DEVELOPMENT APPLICATION ASSESSMENT REPORT

DA2023/0313

Responsible Officer:	Dean Pattalis
Land to be developed (Address):	Lot 29 DP 23447, 67 Woolgoolga Street NORTH BALGOWLAH NSW 2093
Proposed Development:	Construction of a dwelling house including swimming pool
Zoning:	Warringah LEP2011 - Land zoned R2 Low Density Residential
Development Permissible:	Yes
Existing Use Rights:	No
Consent Authority:	Northern Beaches Council
Land and Environment Court Action:	No
Owner:	Scott Kenneth George Shepherd Jessica Laura Shepherd
Applicant:	Rama Architects Pty Ltd

Figure 1: Southern envelope encroachment

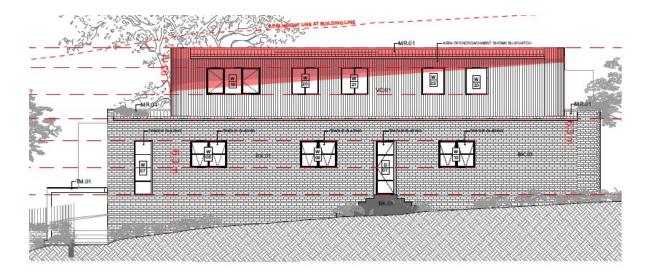
The proposal encroaches the building envelope control on the southern elevation by 0.6m - 1.93m. This represents a maximum variation from the numerical control of 30.63%.

It is noted that this non-compliance is largely the result of the sloping topography of the site which falls towards the south-western rear corner of the dwelling. Therefore, the envelope non-compliance towards the front portion of the dwelling which presents to the streetscape is considerably less prominent than the rear. It is also noted the site is constrained by an irregular lot configuration which requires the built form of the dwelling to be located closer to the southern boundary than the north.

The non-compliance is illustrated below.
